Summary of Early Design Guidance .....13

Design Responses.....31

Property Address: 1405 S Bayview, Seattle, WA 98144	
Owner:	BIHI, LLC
Developer:	Tim Abell, Principal Pacific Housing NW LLC 229 Broadway E. Seattle. WA 981012
Architect:	Weinstein A+U LLC Matthew Zinski T (206) 443-8606
Landscape:	Karen Kiest Landscape Architects Karen Kiest

ENLARGED FLOOR PLAN AND WALL SECTIONS AT NW ENTRANCE PLAZA

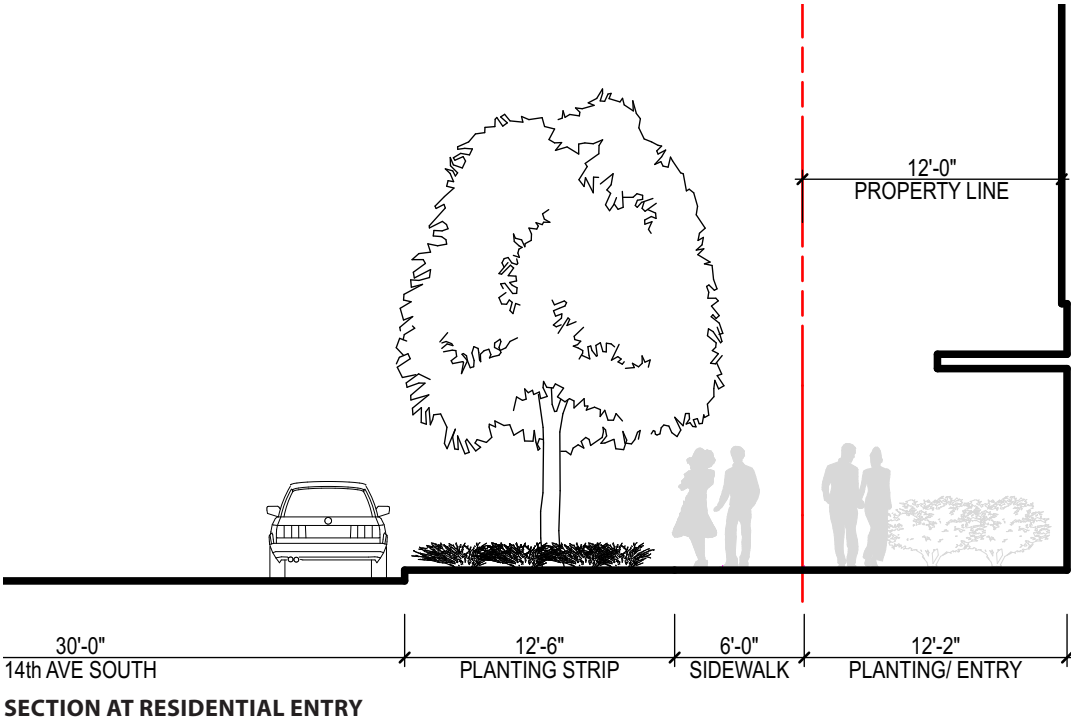
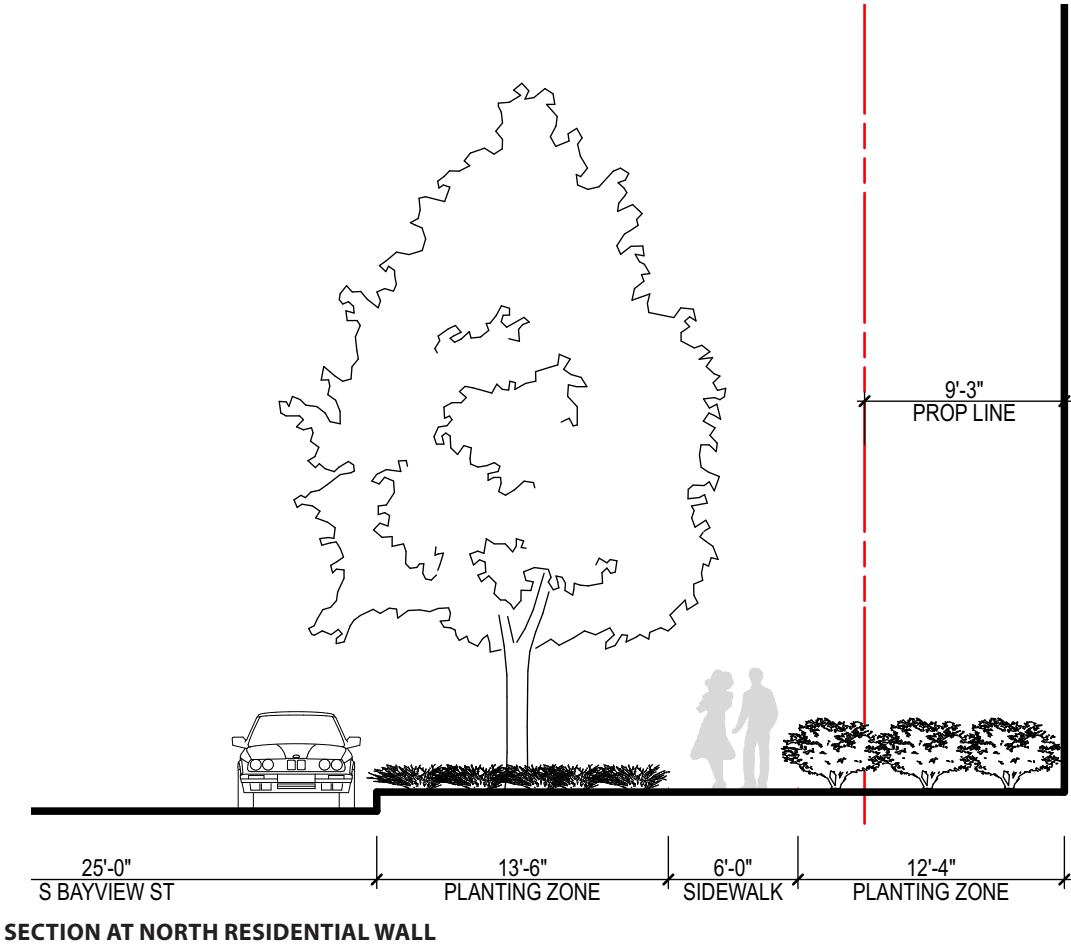
- Massing and Context Response**
- 1d** The three distinctly Beacon Hill design influences, landscape design, material usage & scale, and program, have been articulated at the streetscape level. Brick paired with transparent glass occupies the base of the building for it's tactility and scale. Landscape design is used to provide a curated interface with pedestrians.

- 1e** Emphasis on the corner site is articulated in the landscaping in the setback areas. Providing the mountain-to-island landscape design concept as the ground level provides visual interest, contextually fit with the neighborhood, and provides informal seating.

- Commercial Zone**
- 3d** The mountain-to-island landscape strategy assists in the street-level transition from commercial to residential. The landscaping is taller, denser, and heavier - representing the mountain - adjacent to the retail area. The landscaping scale and texture transitions in scale and texture as it moves down the hill to the residential program on 14th Ave S.

PEDESTRIAN VIEW LOOKING AT RETAIL ALONG S BAYVIEW ST

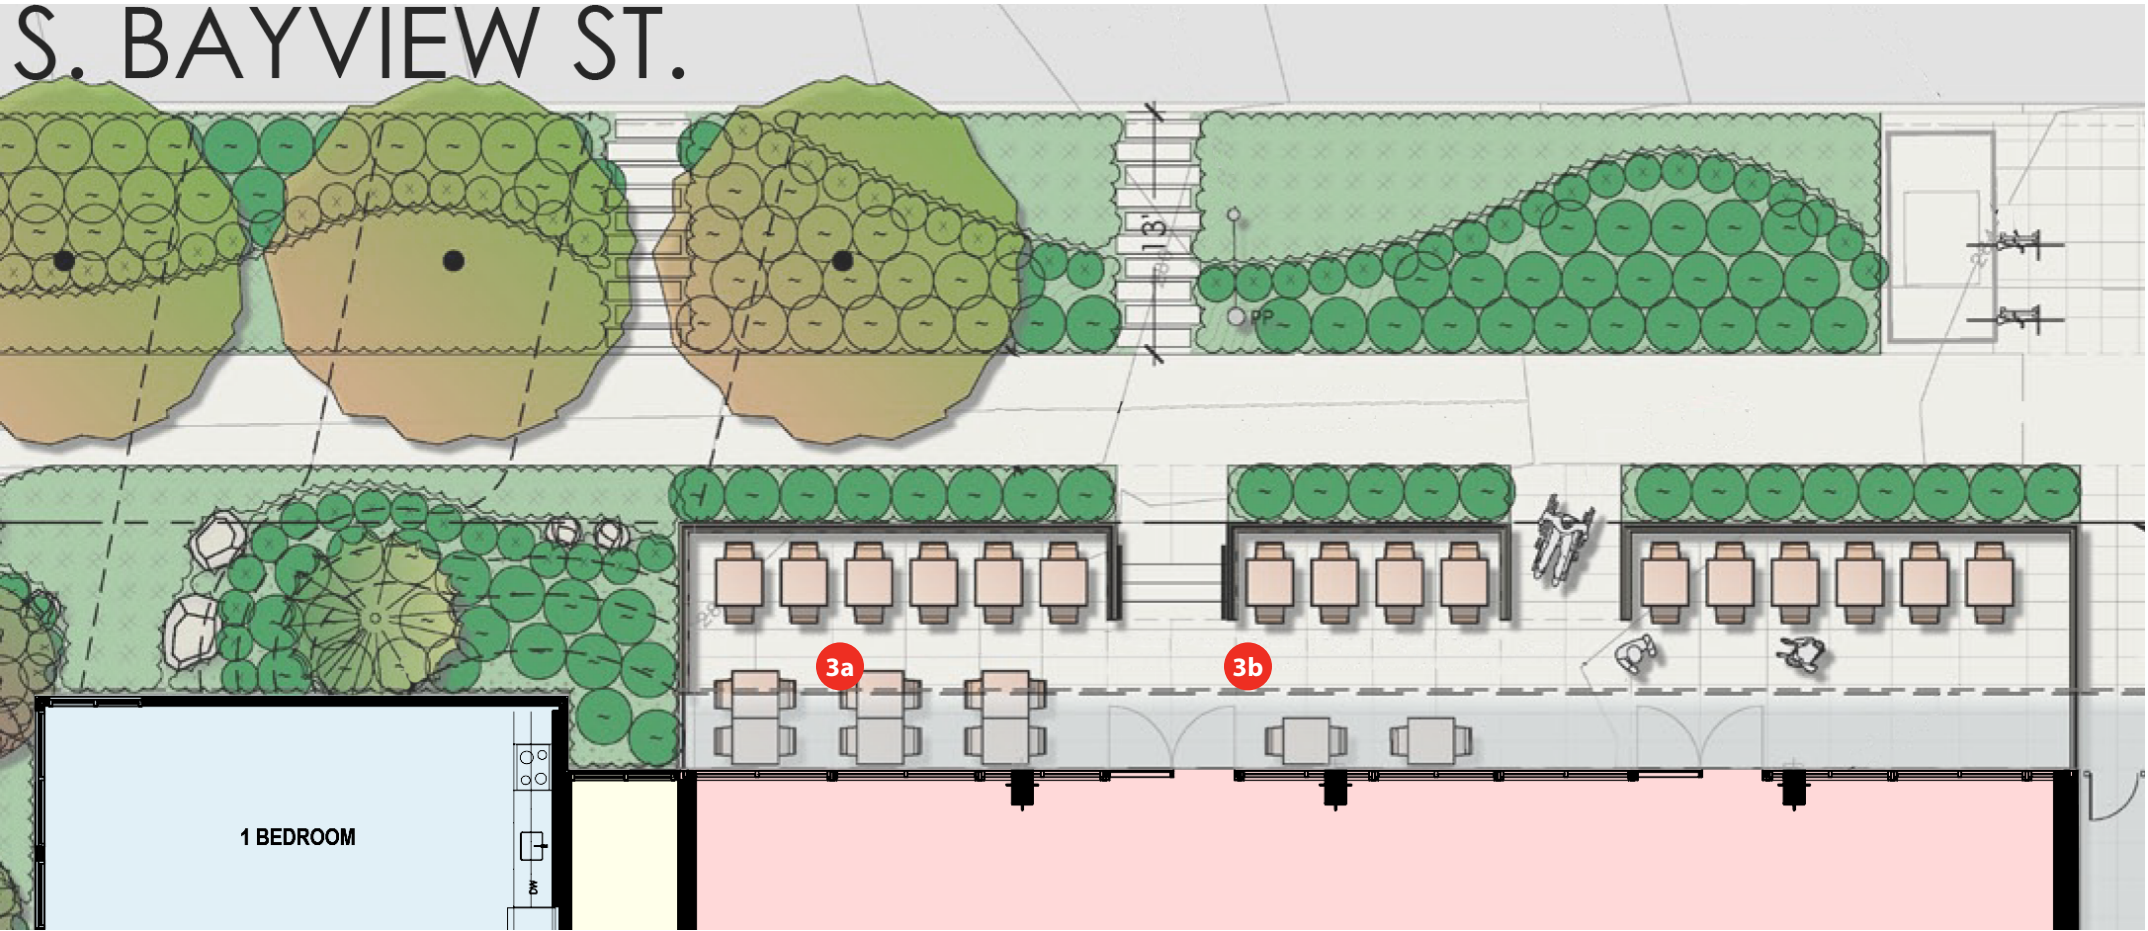
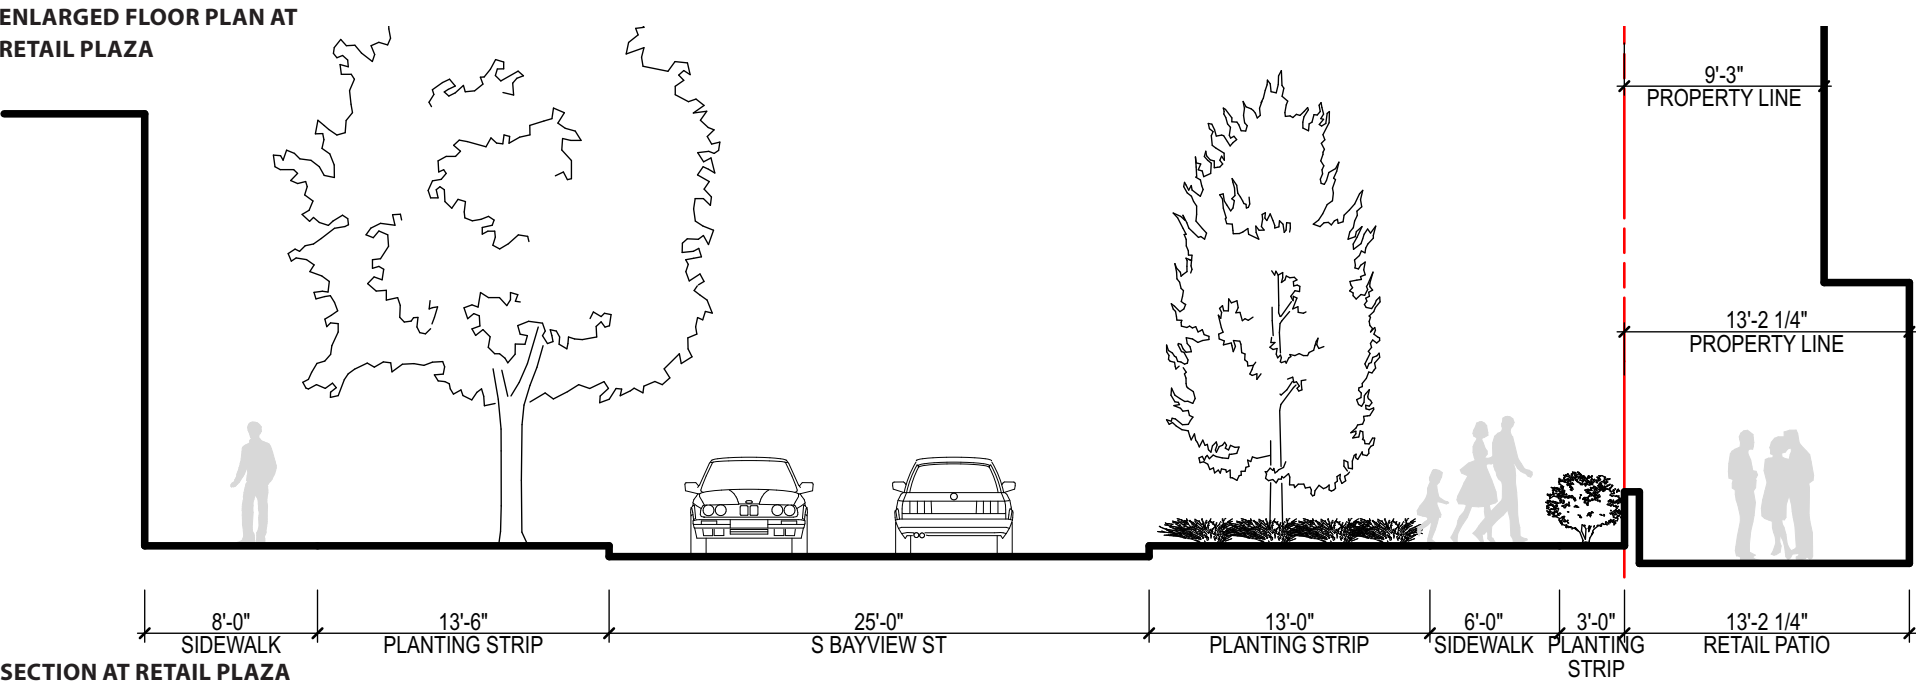
- Commercial Zone**
- 3a** The retail plaza has been expanded from the previous 6-foot depth to approximately 13-feet to better accommodate outdoor, retail activity.
  - 3b** Providing a 13-foot retail plaza allows for two rows of cafe tables and chairs along with circulation space.
  - 3c** The scale of the retail plaza and storefront has been reduced. The storefront height has been reduced by several feet. The retail edge of the retail plaza interfacing with the sidewalk is buffered by landscaping and protected by a transparent railing.

VIEW LOOKING SOUTH FROM BEACON AVE S

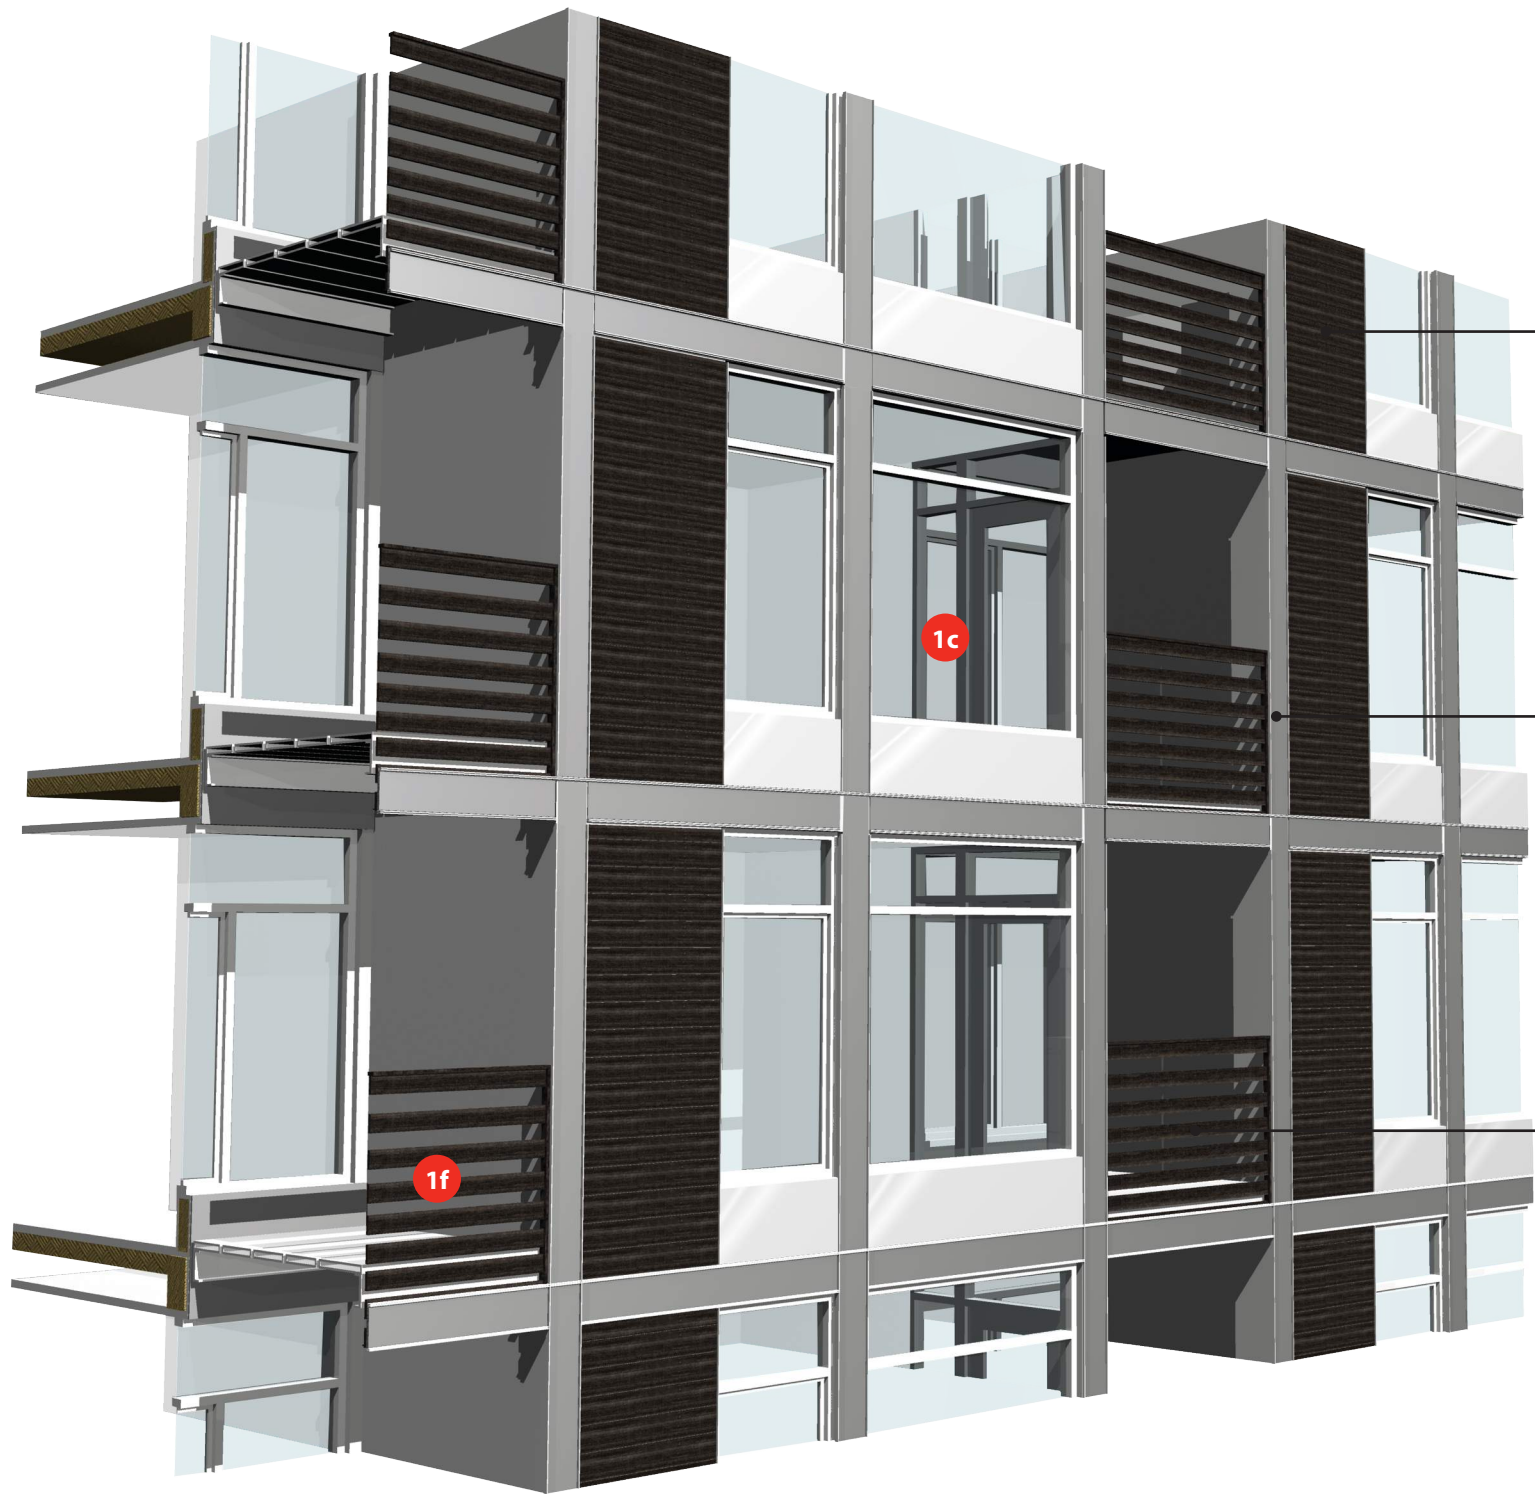
Massing and Context Response

- 1b** In consideration of the zone and scale transition to the south and east, this proposal has reduced the actual and perceived scale. The building has been reduced in height by 1-story. In addition to a reduced mass, the project thoughtfully scales the facade. Dividing the facade into a base and top reduces the perception of height and mass. Organizing the facade in to a grid with material transitions reduces the perceived scale. Adding secondary elements like wood balconettes and an entry canopy provides human scaled texture and shadow lines.

- 1c** The proposed design has been further articulated with a clear facade organization, material application, and secondary elements.
- 1f** The project thoughtfully scales the facade. Dividing the facade into a base and top reduces the perception of height and mass. Organizing the facade in to a grid with material transitions reduces the perceived scale. Adding secondary elements like wood balconettes, inset balconies, and an entry canopy provides human scaled texture and shadow lines.
